THE ROVER COMPANY LIMITED

LAND-ROVER SERVICE NEWS LETTER No. 49

June 1965

Fig. 1. Position of key number for private lock

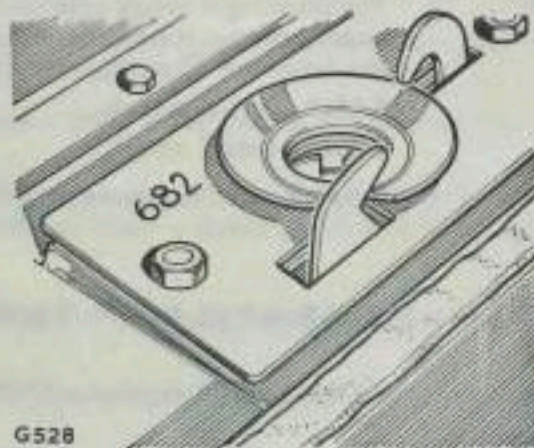
REMARKS: Distributors and Dealers are advised that the key number for Land-Rover models fitted with private locks will be found stamped on the plate adjacent to the bonnet lock as shown in the illustration.
